DIVISION OF WASTE MANAGEMENT AND RADIATION CONTROL

MEMORANDUM

SUBJECT: Review of the Energy Fuels Resources (USA) Inc. (EFR), White Mesa Uranium Mill, Blanding, Utah April 29, 2021, Source Assessment Report for Uranium in Monitoring Well MW-31
Ground Water Discharge Permit No. UGW370004 (Permit)

Figure – Uranium Data Plot of Historical Data at MW-31

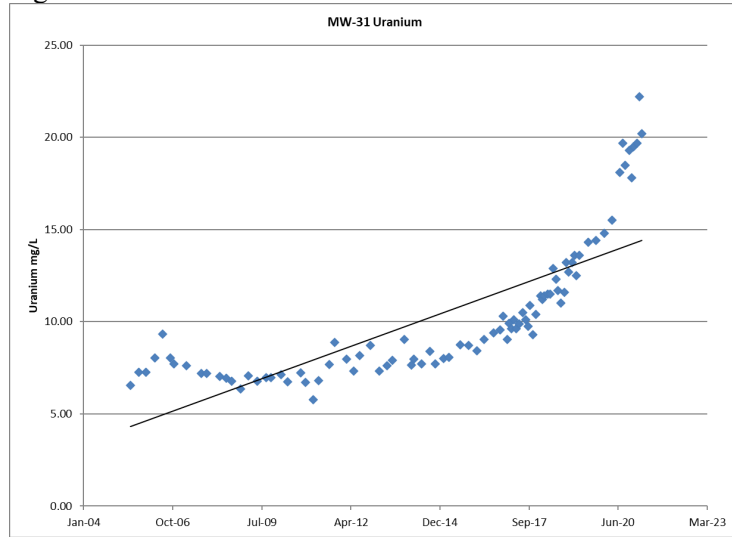
The figure below depicts the time/concentration plots for uranium in monitoring well MW-31. As discussed above it is noted that the concentrations are steepening, although still low per site-wide evaluation:

Per the EFR SAR findings, the GWCL exceedances and data trends are not found to be caused by Mill activities (leakage from the tailings impoundments), and based on the increasing trends, EFR is proposing that a modified approach (background x 1.5) of a post July 2020 data set be used as a basis for the uranium GWCL. Per the plot, it does appear that the post July 2020 data represents a data inflection (steepening and new distribution). EFR statistical review finds that the data within this period shows a normal distribution and justifies the use of the modified data set based on that finding and the finding that the increasing trend was previously identified and studied. The EFR proposal is consistent with the Director approved statistical flow chart and Environmental Protection Agency Guidance (EPA 2009) which allows consideration of a modified approach if a significant trend is evident. DWMRC review findings regarding the SAR, sitewide concentration comparisons, and the EFR proposed revised GWCL’s is discussed below.

Figure – Fluoride Plot of Historical Data at MW-31 – Decreasing Trend

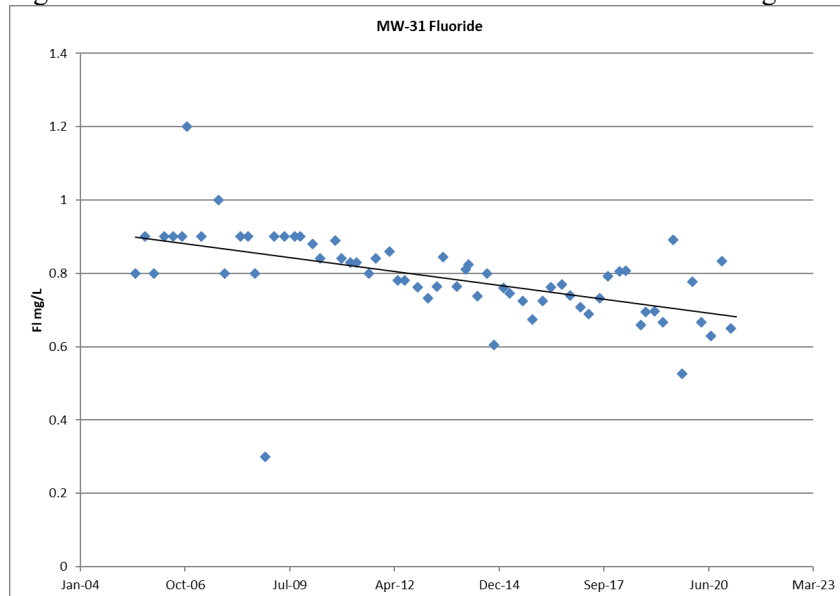
Fluoride is highly concentrated in tailings wastewater and per literature and mill groundwater transport modeling has been shown to be highly mobile in the vadose zone and groundwater beneath the tailings impoundments. Per the figure below, fluoride is showing a decreasing concentration trend in MW-31.

Mass balance calculations for fluoride have been reviewed by DWMRC. Per findings the concentration of fluoride in groundwater when compared with less mobile constituents in tailings wastewater are much lower; additionally, as per the figure above overall concentrations are declining but would be increasing due to input of tailings wastewater which is high in fluoride concentration. Previous EFR SAR's used a comparison of selenium and fluoride in Cell 1 tailings wastewater and MW-31 groundwater and concluded that selenium is found at much higher percentages in groundwater than fluoride. DWMRC has additionally conducted additional Cell 1 evaluation of mass concentrations in tailings wastewater compared to concentrations in MW-31 and found that that the MW-31 concentrations are not consistent with a tailings source. Fluoride concentrations should be over 20 times higher to indicate a relationship with tailings wastewater.

Figure – pH in monitoring well MW-31

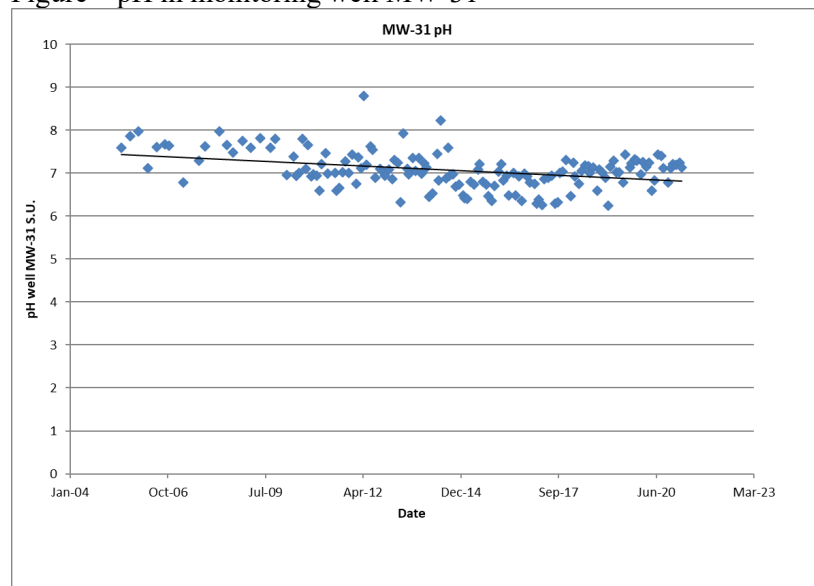
Section 3.1 of the SAR includes a summary of site-wide decreasing pH and refers specifically to the discussion of “Site-Wide Decreasing pH,” and, Section 3.4 and Appendix D of the previous 2020 SAR which included a comprehensive evaluation of pH in MW-31 and evaluation of the decreasing trend. Per the current SAR and statistical analysis (included in Appendix A of the SAR) more recent data show that pH is stable to increasing at near neutral values. Review of the recent pH data is not consistent with a tailings source and may support findings of the previous and ongoing EFR pH and pyrite investigations.

Figure 5 – Concentrations of Atmospheric Tritium in the Southwestern United States

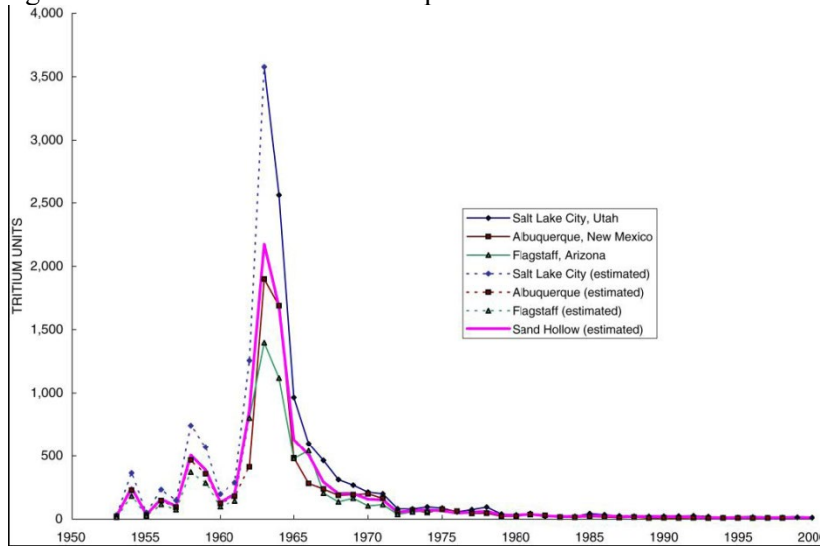
be expected in ground water samples in monitoring well MW-31. Figure 5 below is taken from the University of Utah (“U of U”) Report (Hurst and Solomon 2008) and depicts atmospheric concentrations of tritium in the southwest by year.

Based on review of the U of U Report and specific data results for monitoring well MW-31 age dating of groundwater at the well indicates that the MW-31 groundwater predates Mill construction.
